Service Letter

Service Bulletin No. /
Date: SL TMG 125-1004, Initial Issue / October 10, 2014

Subject: Inspect the attachment of the alternator loom

Type affected: TAE 125-02-99 and TAE 125-02-114

Figure 2 alternator support WITH the tapped hole

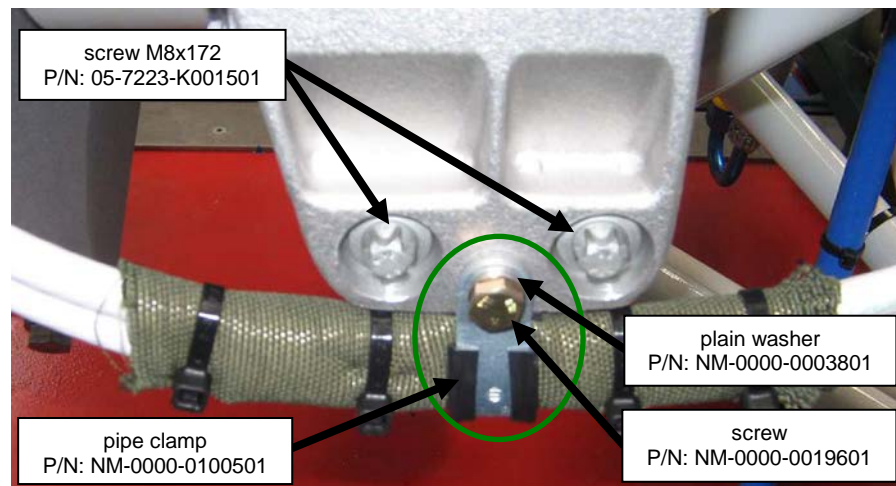
In case of the alternator support WITH the tapped hole is installed

- ◆ **Note:** Check that the correct screws M8x172 are installed.
The bottom screws on the alternator support must be screws with external torx M8x172-8.8 P/N: 05-7223-K001501. See Figure 2.

1. Remove the wrong attachment.
2. Attach protective sleeve (2x150mm) (P/N: NE-0000-0069301) around the lines.
3. Install the clamp (P/N: NM-0000-0100501) around the protective sleeve and the lines.
4. Attach the clamp with a screw (P/N: NM-0000-0019601) and a washer (P/N: NM-0000-0003801) on the alternator support. See Figure 2.

Tightening Torque:
10 Nm (89 inch-lbs.)

Figure 3 alternator support WITHOUT the tapped hole

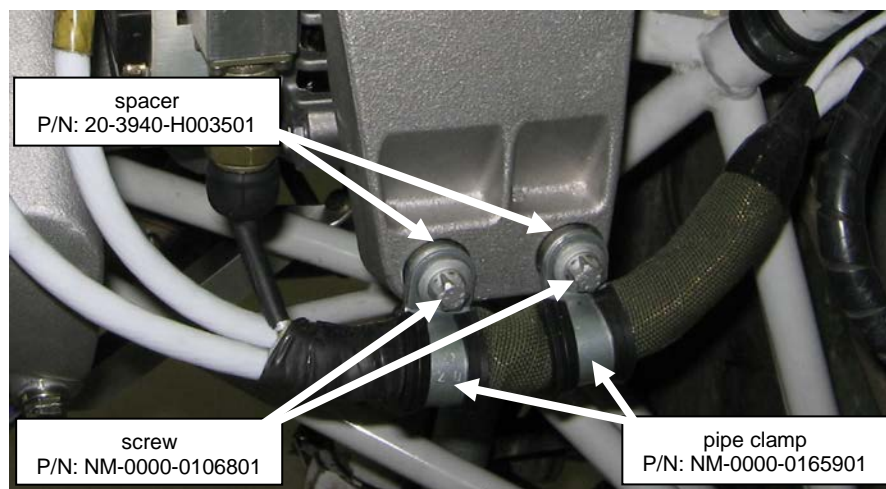
In case of the alternator support WITHOUT the tapped hole is installed

- ◆ **Note:** Check that the correct screws M8x190 are installed.
If not, follow the instructions below.

1. Remove the wrong attachment.
2. Attach protective sleeve (2x150mm) (P/N: NE-0000-0069301) around the lines.
3. Install the clamps (P/N: NM-0000-0165901) around the protective sleeve and the lines.
4. Attach the clamps, each with a spacer (P/N: 20-3940-H003501) and the screws (P/N: NM-0000-0106801) of the alternator support.
See Figure 3.

Tightening Torque:
20 Nm (177 inch-lbs.)
